Access Compliance Report

Public Rights-of-Way

(Curb Ramps)

Intersection ID: 10038957	Main Street: STONEMEDE_LN	Cross Street: N/A	Location: E
ADA ID: 08317CDB2496	Ramp Type: Perp	Initial Pass/Fail: Pass	Overall Compliance: No
Severity Score: 5			
Codes/Mitigation Info/Possible Solution		Field Measurements/Component Compliance

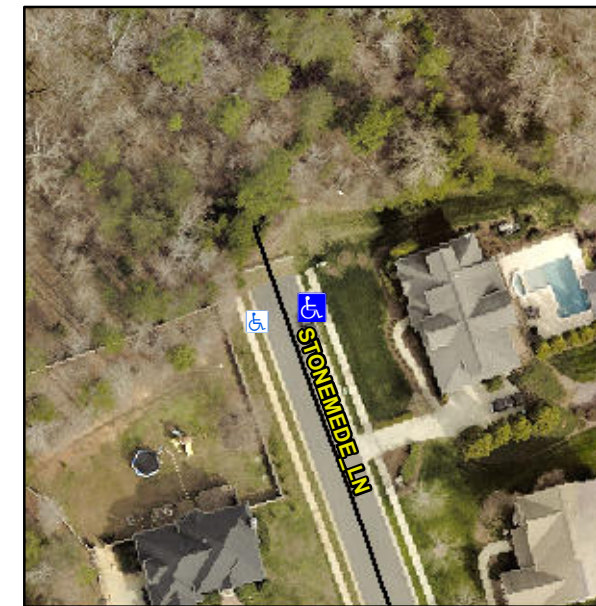
Not Found, R304.5.4

**Remove & Replace Entire Ramp.
Remove & Replace Gutter.**
